APPLICATION NO.	FILING DATE	FIRST NAMED INVENTOR	ATTORNEY DOCKET NO.	CONFIRMATION NO.
10/529,545	03/29/2005	Yutaka Inoue	1907-0220PUS1	7871

Office Action Summary	Application No. 10/529,545	Applicant(s) INOUE ET AL.	
	Examiner LEAH S. LOVELL	Art Unit 2885

DETAILED ACTION

FIGURE A: Figure 5 of Murase modified to show clear position of driving means.

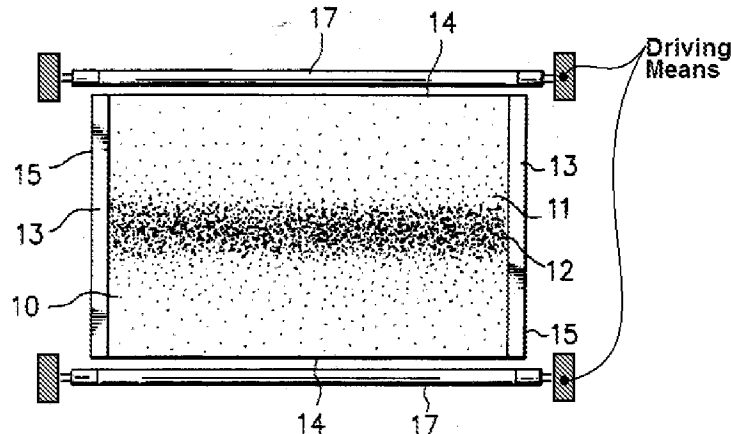
Furthermore, Applicant asserts that Murase provides "no description regarding the position where the driving means is arranged...there is nothing inherent regarding where a driving means is provided." The Examiner, again, respectfully disagrees.

Clearly driving means are required by the lighting device of Murase because it is a well known fact that fluorescent tubes, like those of Murase, require driving means to power the bulbs. As far as positioning goes, based on the tubing, driving means would be positioned at each end to support—which meets the claim limitations—and provide electrical current to drive the light sources. Figure A has been provided below with driving means added in a position that would be clear to those having ordinary skill in the art.
